# **A G E N D A**

## **Architectural Review Board**

**September 22, 2015**

*1327/1329 Woodward Avenue*

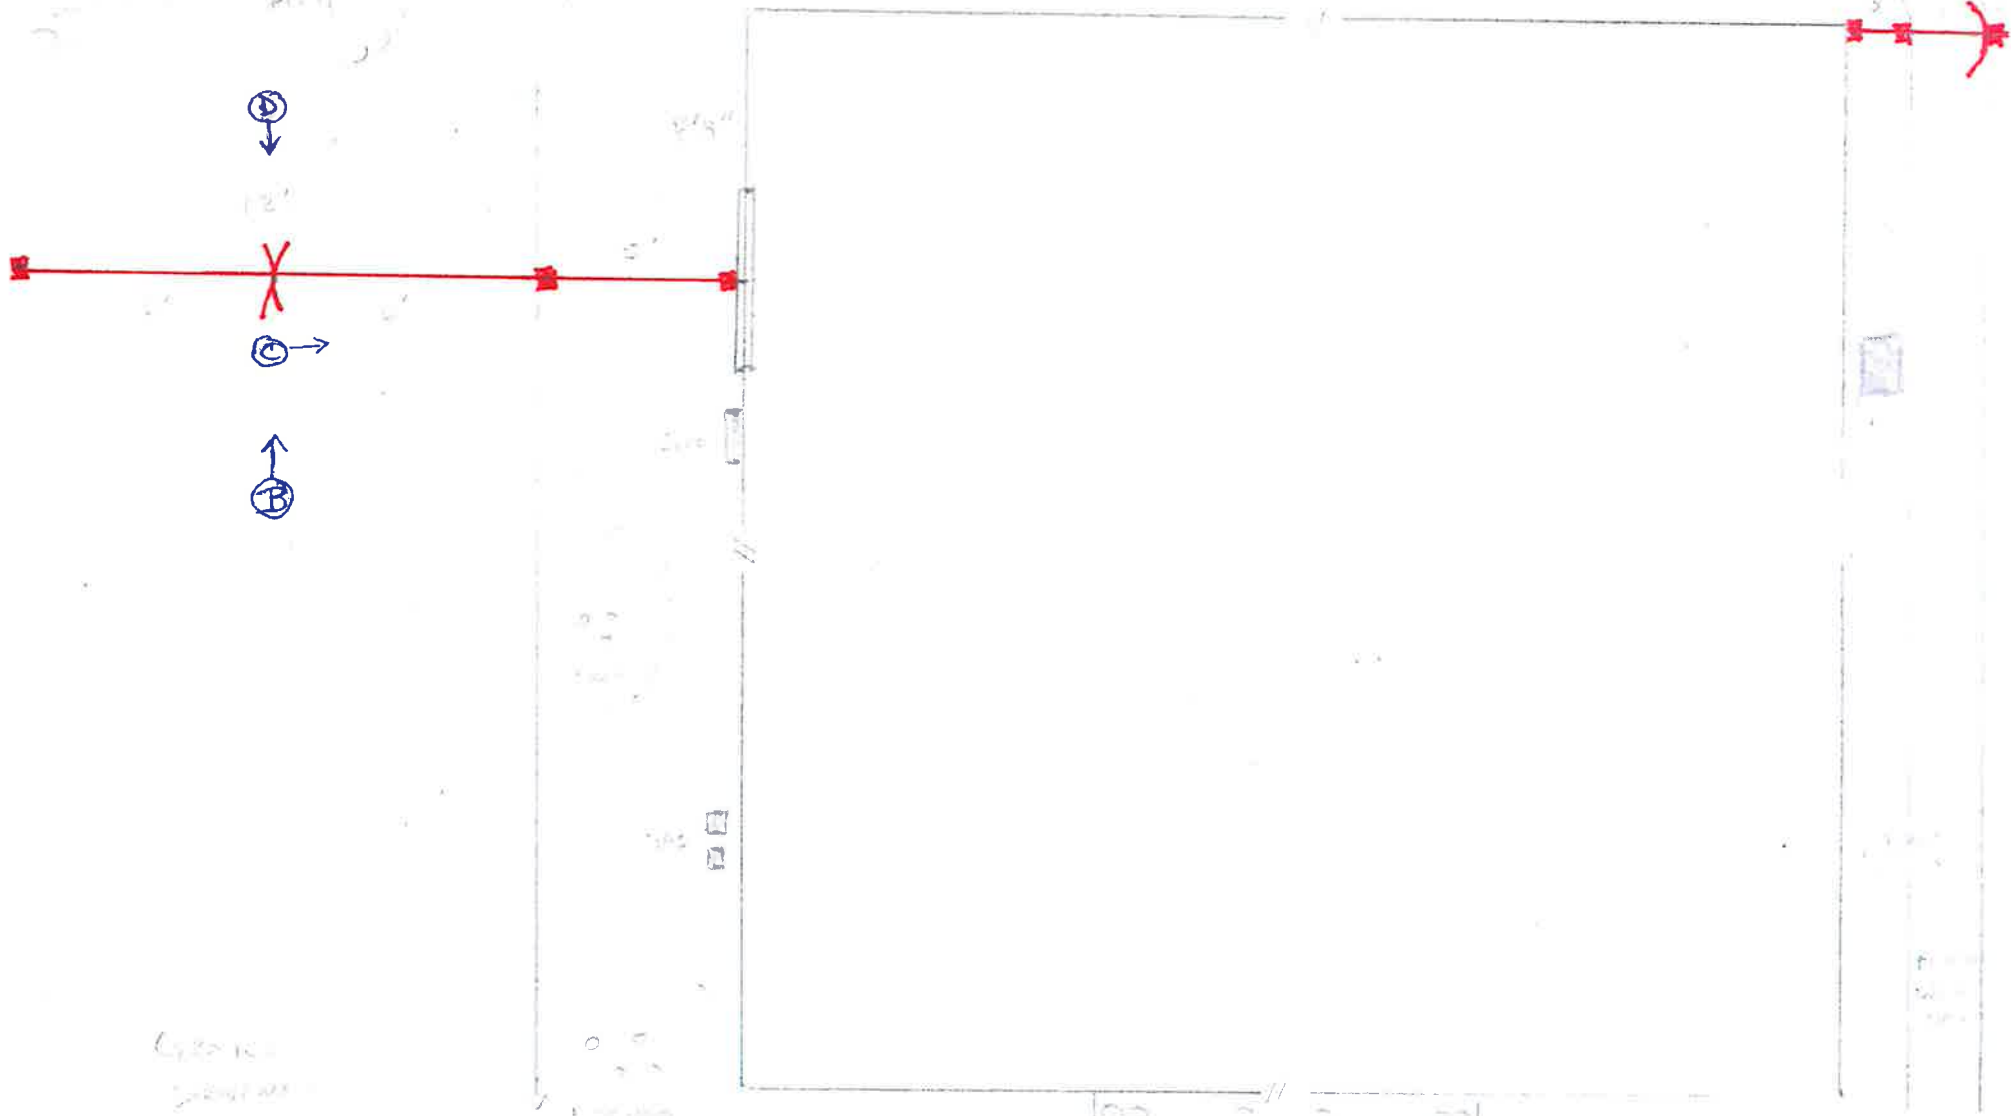
- The Board has generally approved wood fences and gates, particularly those located at the rear corners of the house.

2232 Winona Avenue

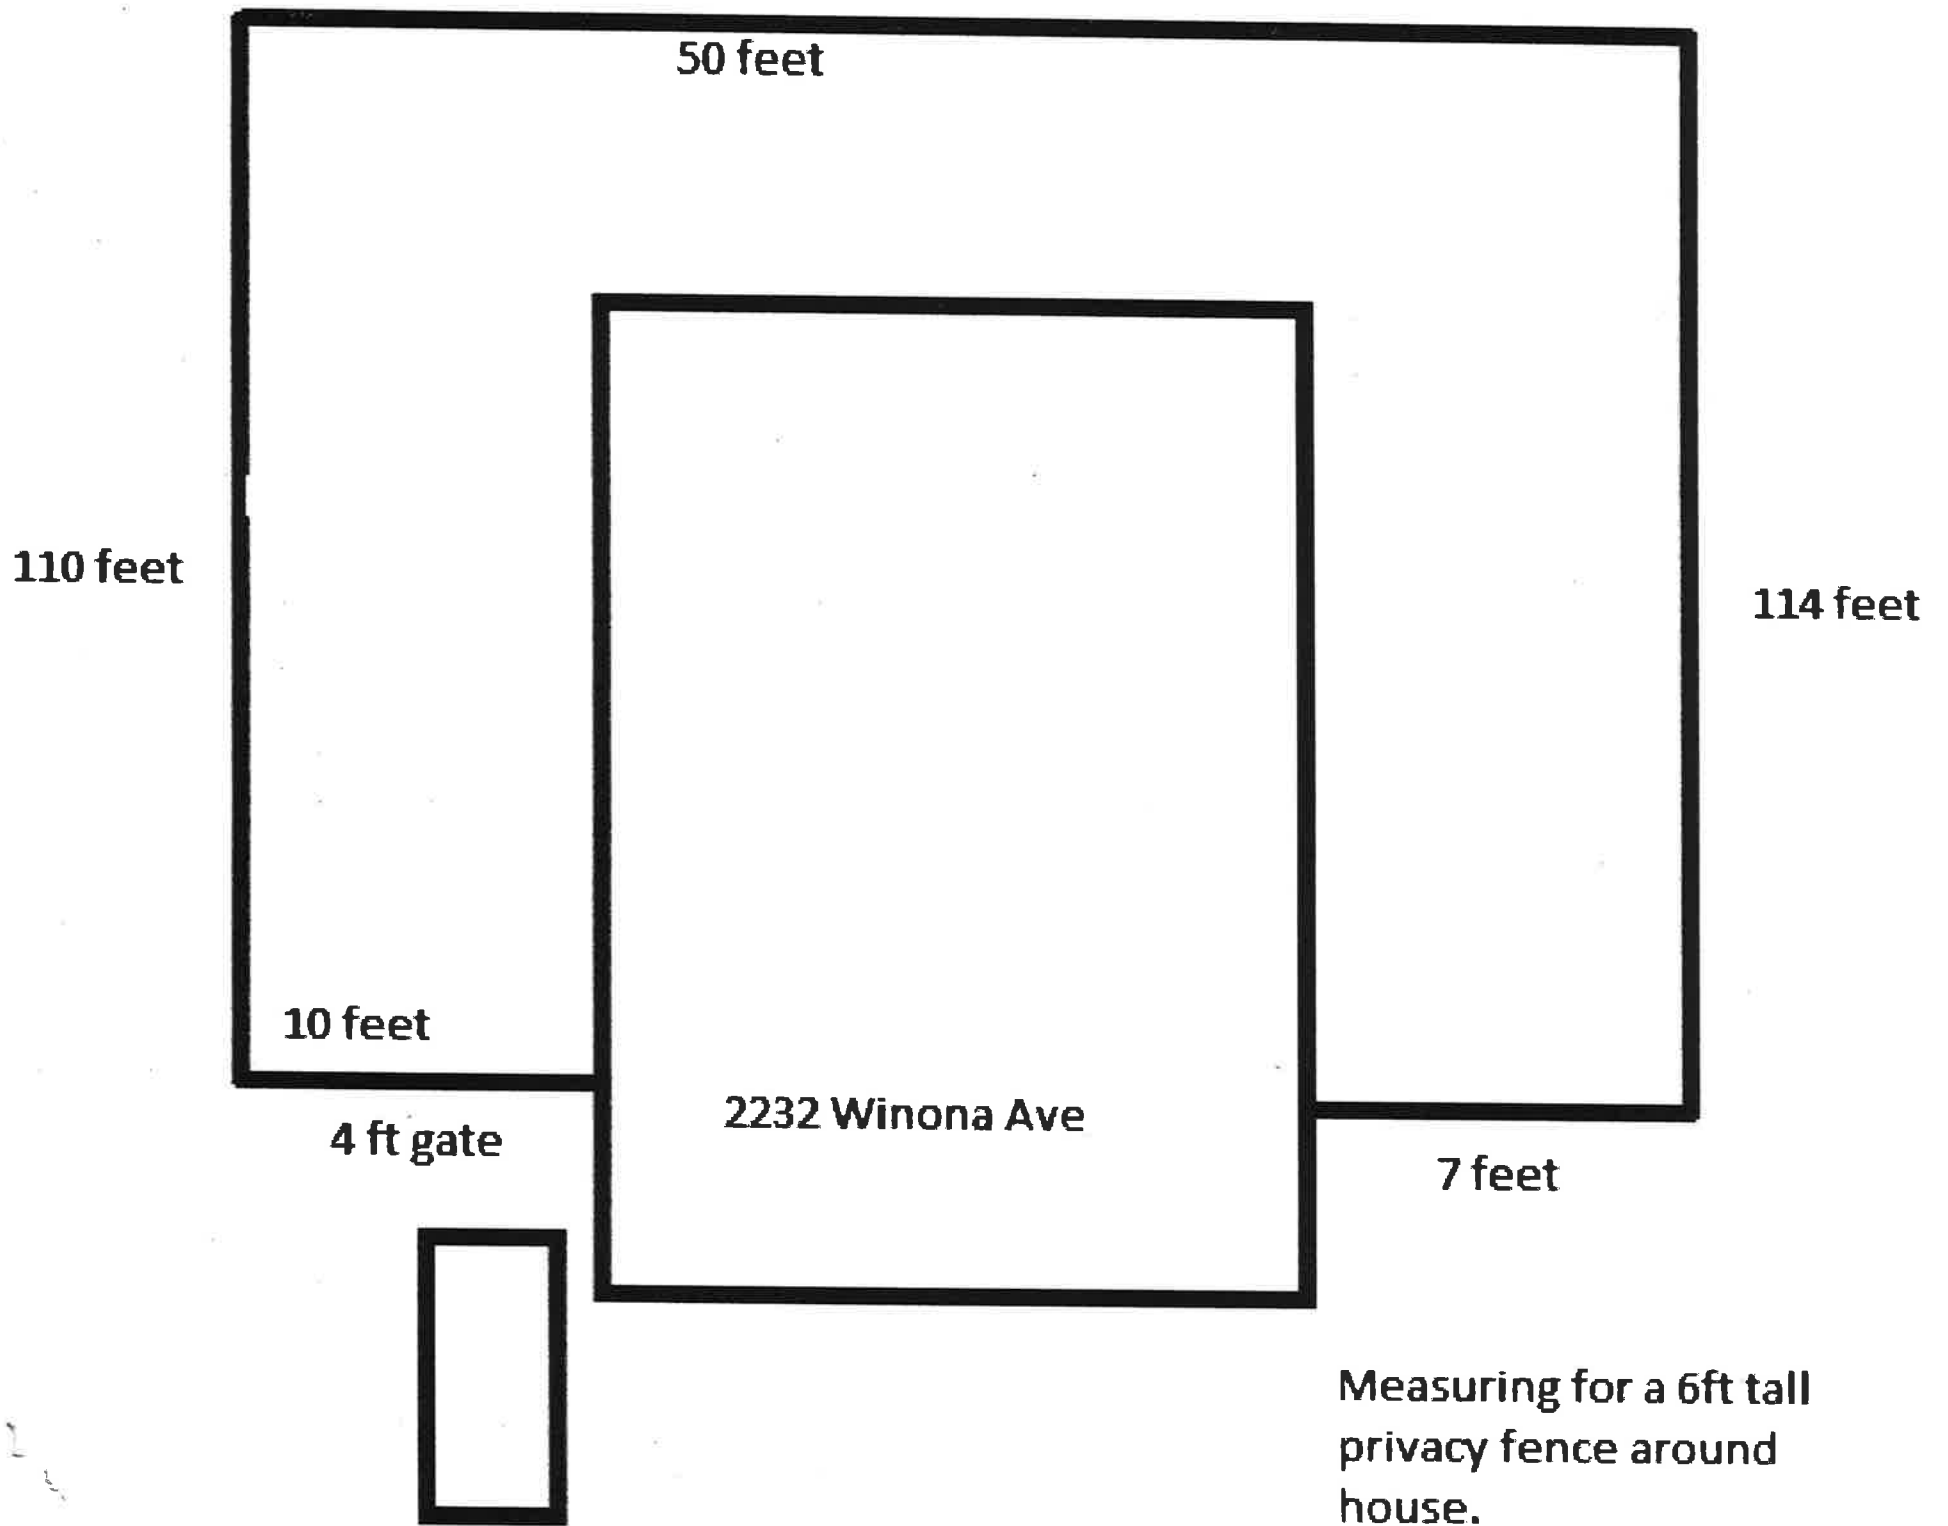
- The Board has generally approved wood fences. In this case the Board should consider if the fence is recessed far enough from the front corners of the house to prevent a stockade effect.

*79 Commerce Street*

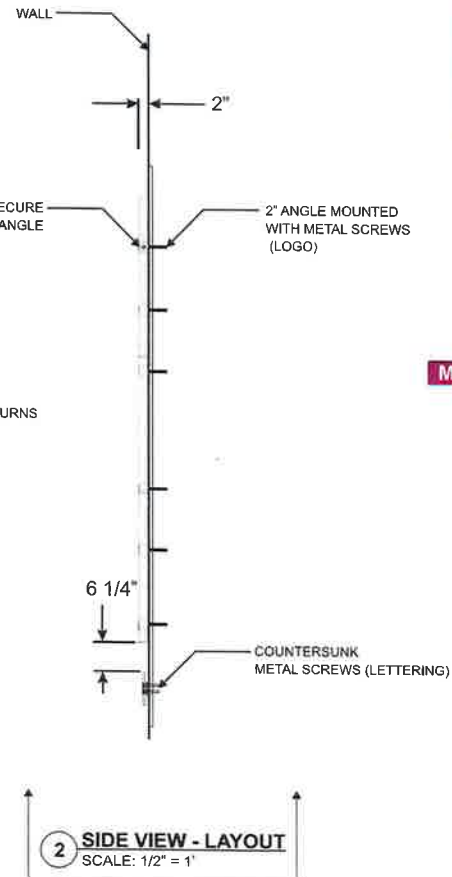
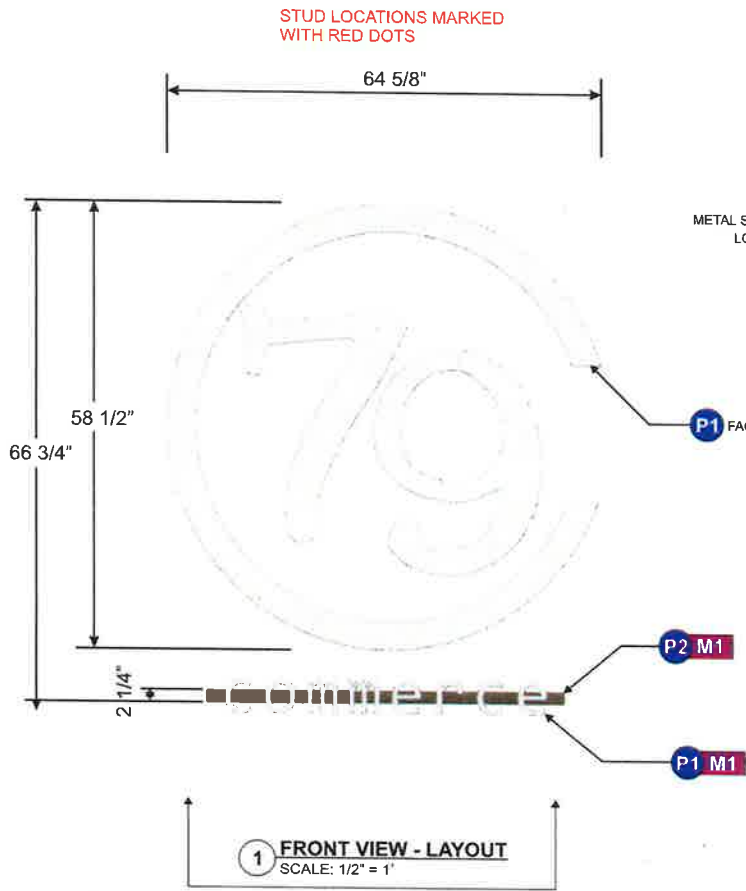
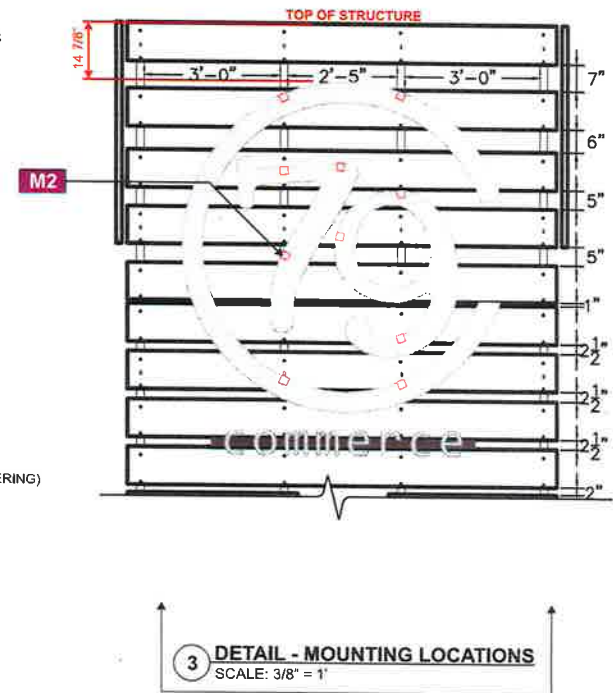
- Sign guidelines read: Proposed signs should not exceed 20 square feet of surface area. Designs for the mounting, framing, etc. must be approved. The material for the mounting should be compatible with the materials in the building. Style and color of lettering must be compatible with the building and location. Location of the sign on lot must be approved. Lighting: top or ground lighting such as floods or spots. Interior lighting if shielded. No moving or flashing lights.
- The Board has approved larger signs when the scale of the building could accommodate it and the overall size did not detract from the building.
- The sign is slightly larger than the 20 SF; the sign meets lighting standards with no illumination.

2625 Girard Street

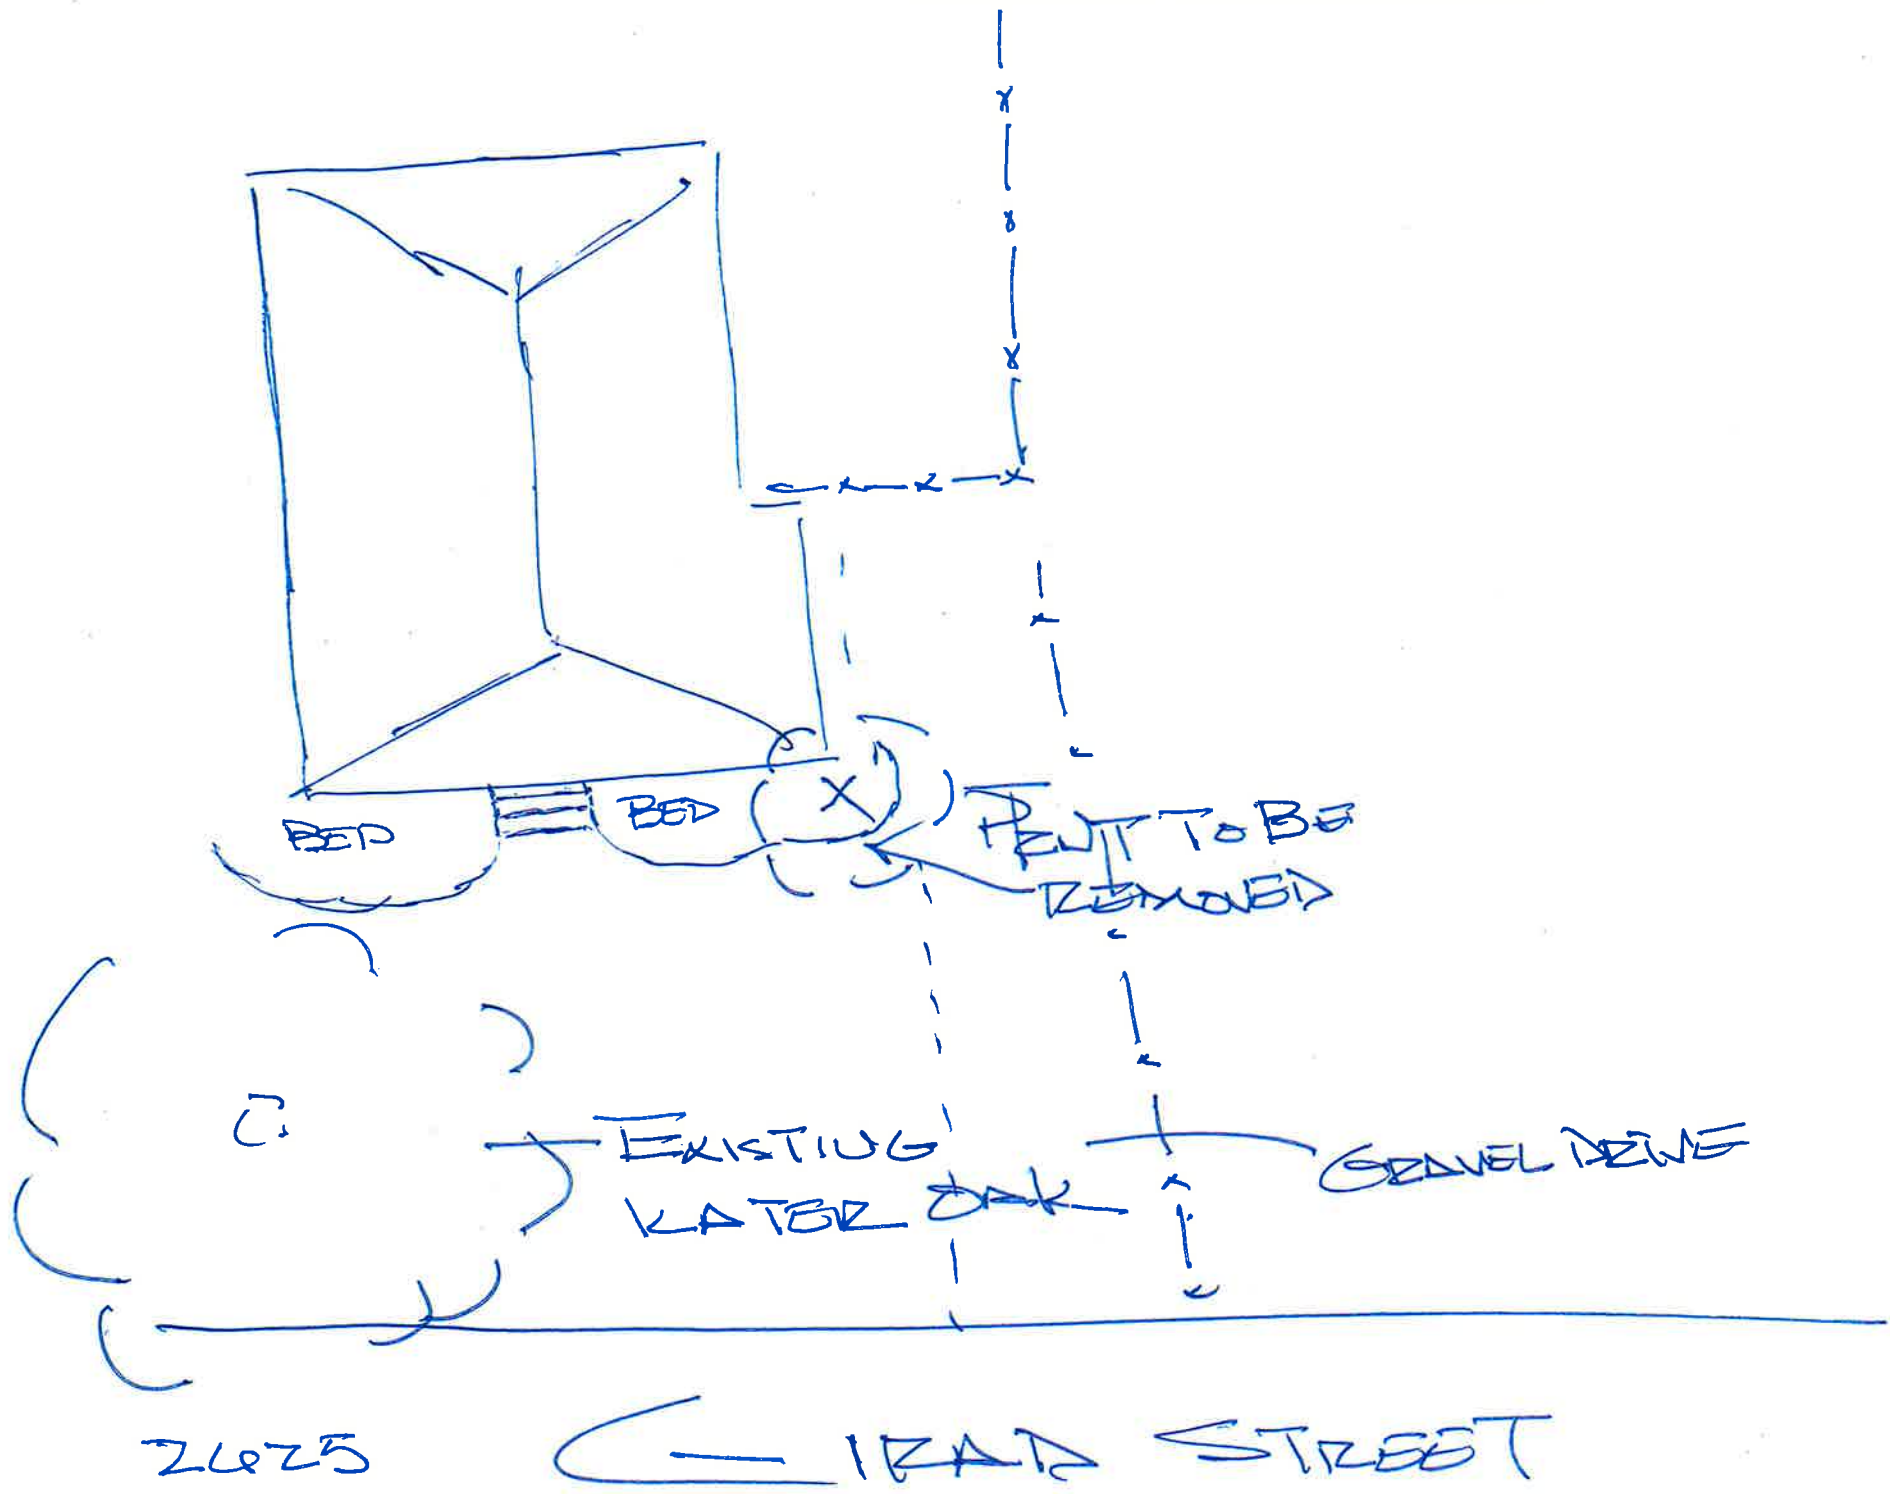
- Urban Forestry has no objection.
